NOTICE OF PUBLIC MEETING

Memo

To: PLANNING COMMISSION
From: SAL AGUIRRE
CC: CITY SECRETARY
Date: 10-8-2016
Re: October 10, 2016 HIGHLIGHTS AND ISSUES AGENDA

1. FINAL REVIEW AND ACTION ON PLAT OF BLOCK 1, LOTS 1, 2, 3 & 4 OF THE RESERVE AT LAKE JACKSON, FOR THE APARTMENT DEVELOPMENT AT 202 FM 2004 (TENTATIVE)

BLOCK 1 - LOTS 1, 2, 3 & 4 THE RESERVE AT LAKE JACKSON

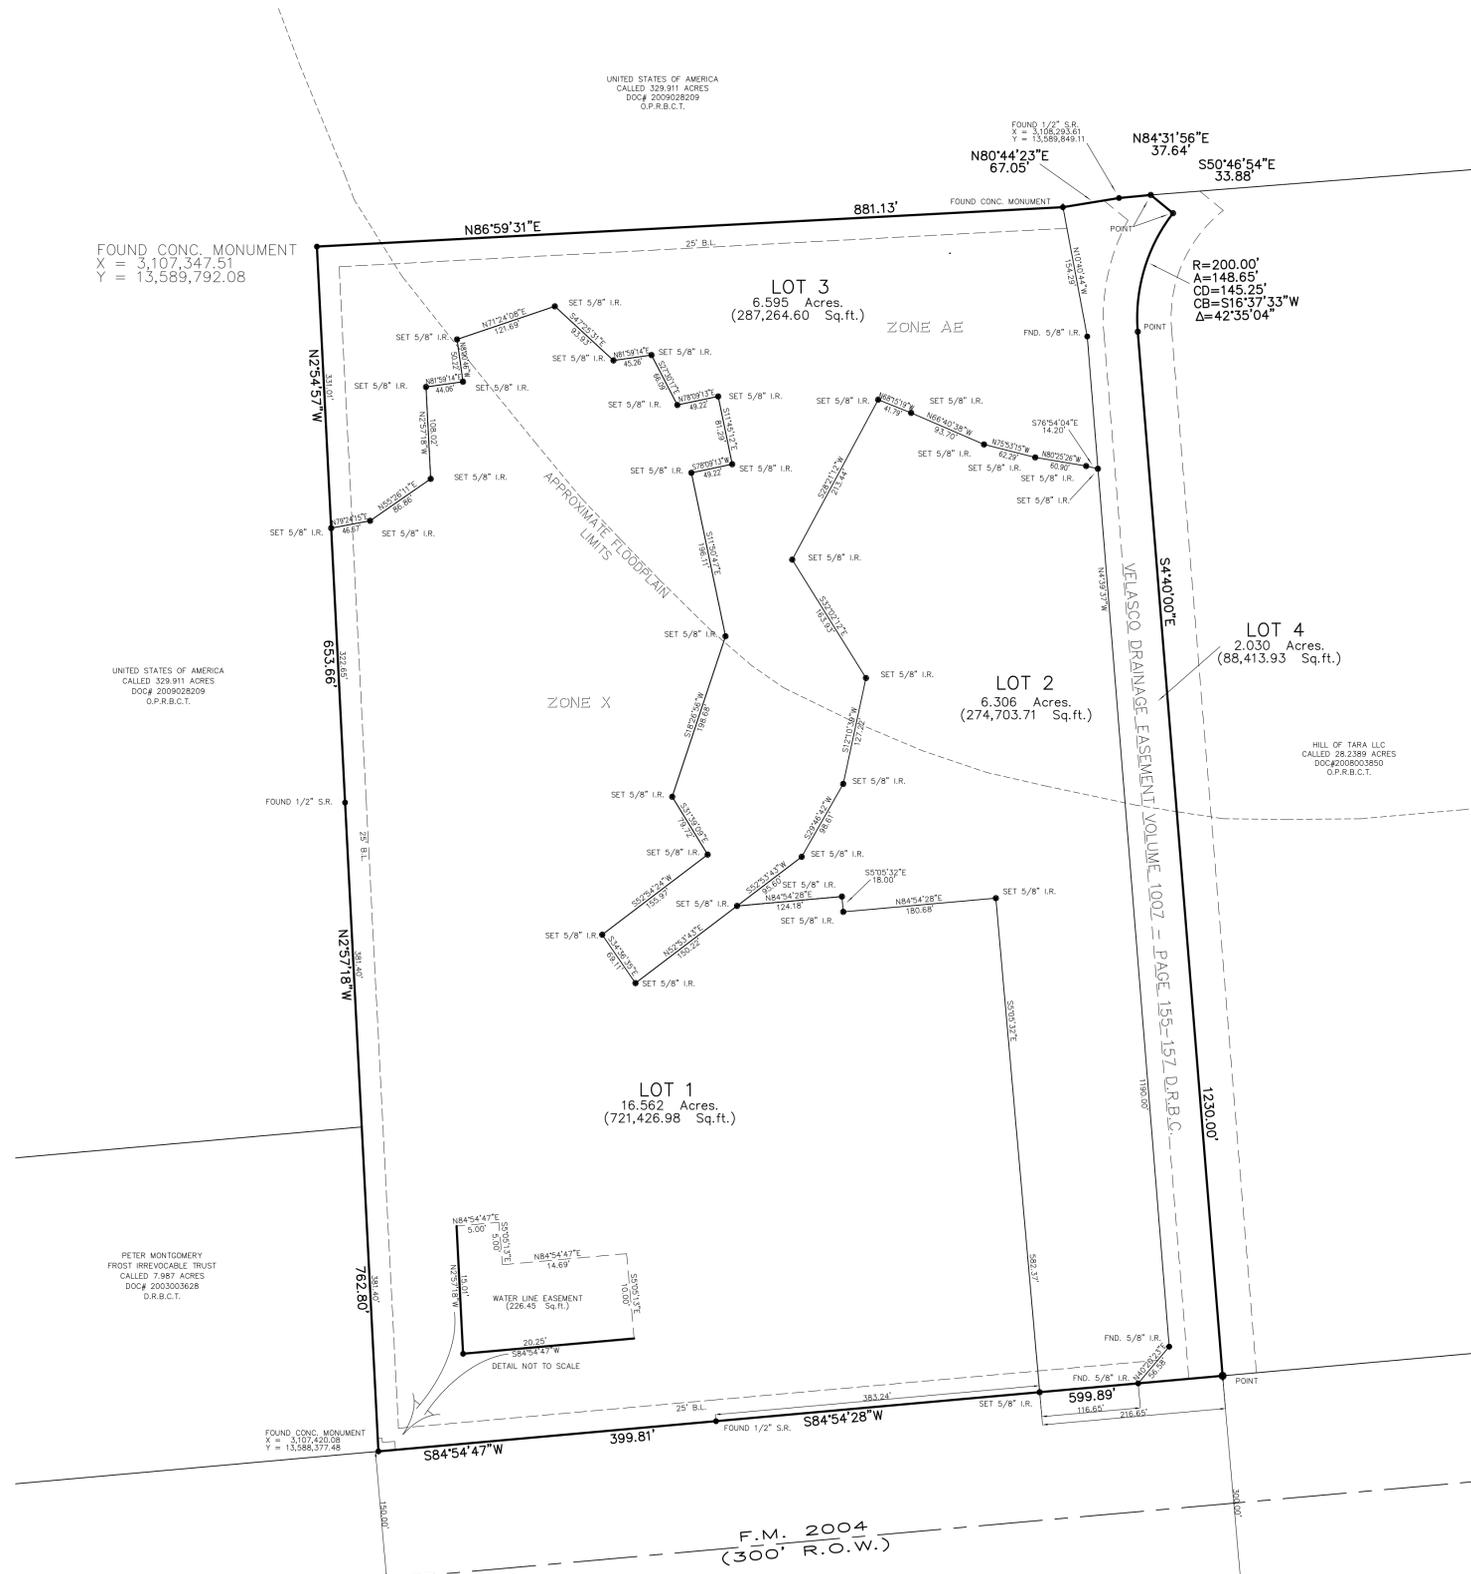
The preliminary plat as submitted underwent some fluctuation due to the difference of opinion of the consultant and city staff in determination of the FEMA floodplain line location within the property. After lengthy dialogues its final agreed location was arrived and indicated in the plat. The development implications of this line on the lot line as platted was made known and acknowledged by developer with a future LOMR-F revision action in mind. The final partition configuration did not change from the preliminary and only added revisions to the utility and drainage easements on account of the needs and development discussions made known by city or drainage district staff during the period. All format and platting content has been tweaked to the required standards and the plat is ready for your approval consideration without issues.

At our previous discussion, the hold up with VDD surveyor's difference and easement ownership was brought up as having been resolved to everyone's satisfaction. The results being an agreement on the survey line description and granting VDD easement as a fee simple title to the land by creating an additional lot 4 for that purpose. This has been done in this final plat and all issues have been cleared for your consideration of final.

SHEET NO.
L1.26

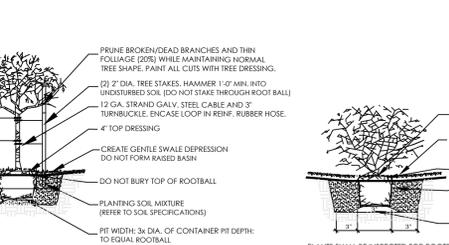
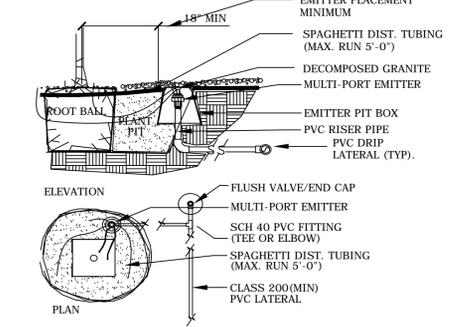
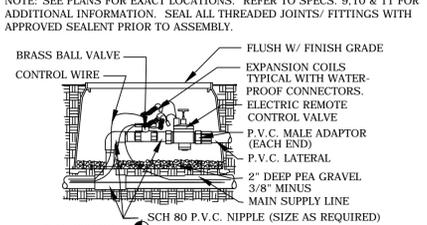
The final plan has been updated to address the requirements of the board from the last meeting which was to include the 12" - 18" tree survey along the west and highway boundary of the site as a minimum. This resulted in the inclusion of an additional 10 tree of which 6 would be removed and 4 to be saved.

This is qualified alternate plan because 1) a variance tree survey has been granted 2) it allows a phased in landscape plan in lieu of a master plan by leaving landscaping development of Lot 2 for the future and indicates the remaining lot 3 to stay in natural condition. Given the tree survey modification, the plan claims that 122 of those in the survey will be removed while 32 will be protected within their open area plan. The required tree count of the site design calls for 82 tree (indicated as 52 by their interpretation) and to be corrected. To supplement the count they have incorporated an additional 122 trees for a total of 160 native trees which significantly satisfies the requirement. The plan still claims a credit for the 32 protected trees, which will need to be deleted to avoid future replacement liability. We anticipate this to happen prior the meeting.

The landscape area plan indicates a mix of designed open space and detention area space to comply with ordinance requirement. Based on the site design, a total of 68,000 sq. ft. of open landscape area is required

which is shown in the plan (34,900 sq. ft. by their interpretation) and to be corrected. The plan claims as providing 274,400 sq. ft. of open landscape which still needs to be properly accounted for validation. We anticipate this to happen prior to the meeting.
